W.MOTOR SERVICE j.s.c.

INFORMATION BULLTEIN

No.: M4-III/43b

CONCERNS TO : replacement of Scintilla magneto by magnets PAL type. sign LUN 2225 on engines M4- III .

Figure no. 1

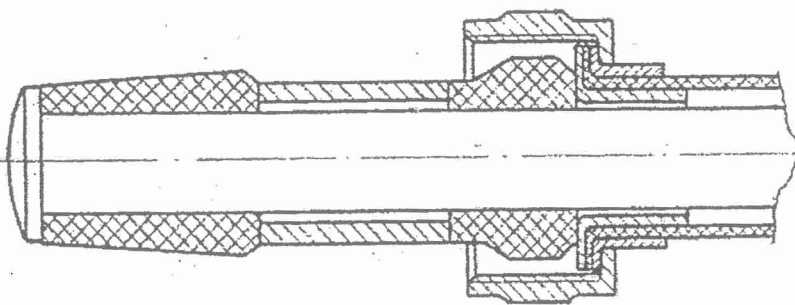
b/ When a magnetos PAL are using, is necessary to adjust the cable end inserted into the magneto as shown in Fig. 1

b/ Adjusting the cable ends according the fig.1 Before adjusting, the cable shield should be reduced by 15 mm. After insertion of the all required detail to make soldering wires to the washer502-0904.27.

Note: Details sn. 402-0760.36, 502-4200.74, 502-7211.82, 502-0904.27 are supplied with magnetos PAL.
